Certificate of Appropriateness

1842 N. 2nd Street, Brewers Hill Historic District

Replace an existing wood fence with new dog ear white cedar privacy fence per the plan and scope of work below.

Date issued 8/20/2024

Plan and scope of work for new white cedar dog ear privacy fence.

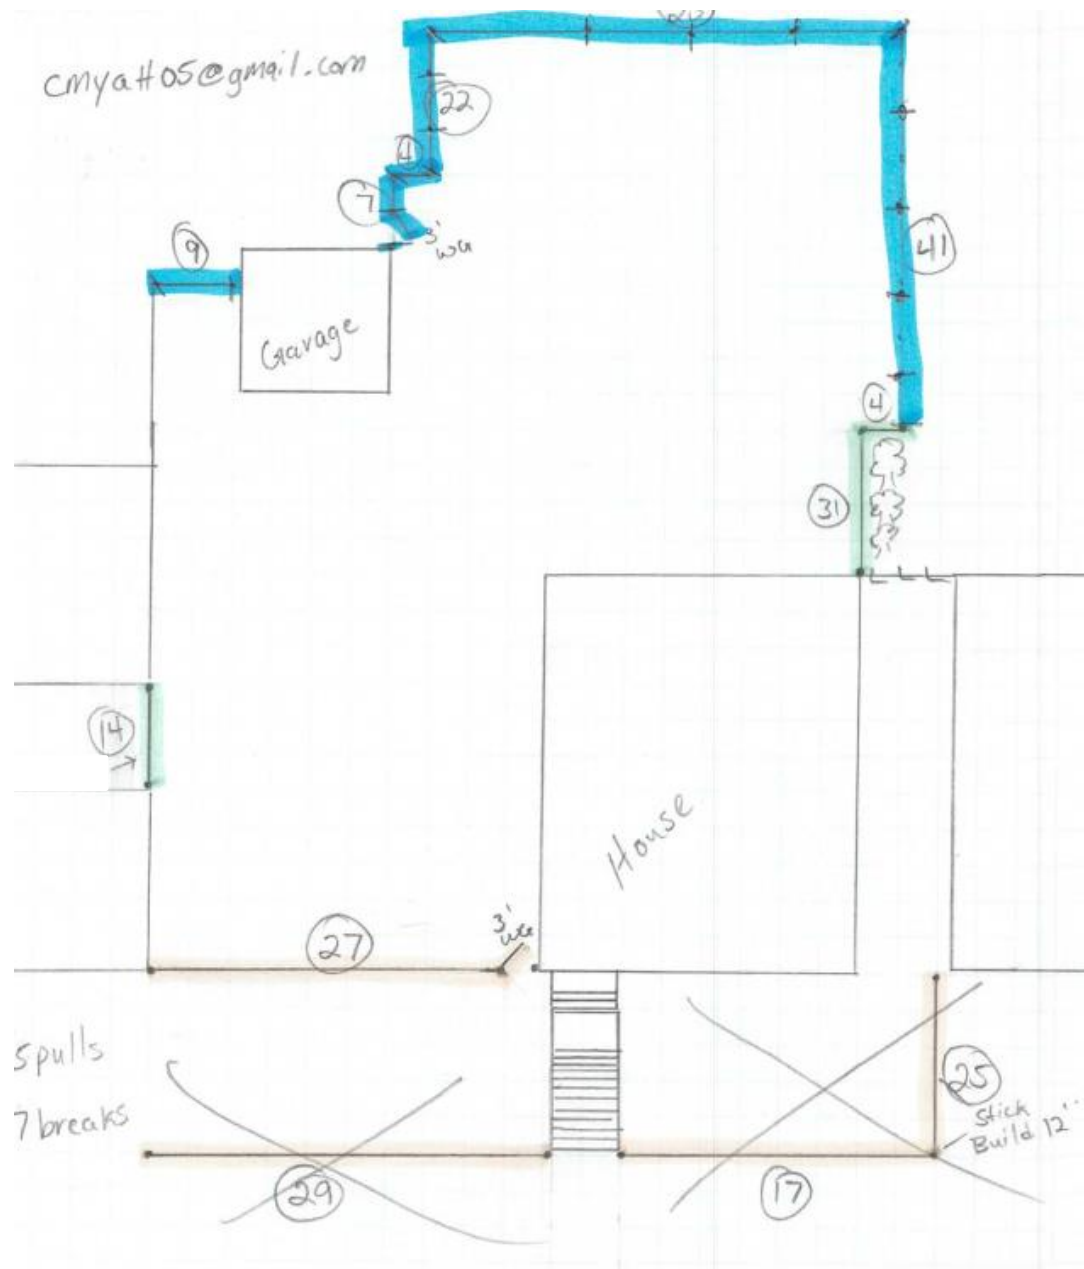
All wood must be smooth and equivalent to #1 grade cedar or better for use in rear and side yards. Sections of fence forward of or in line with the primary building's front setback must be clear grain. Wood fences must be painted or stained upon completion. Note: when new, bare wood is left exposed to the exterior elements for a period of only a week or two, the life of the finish subsequently applied to it will be decreased.
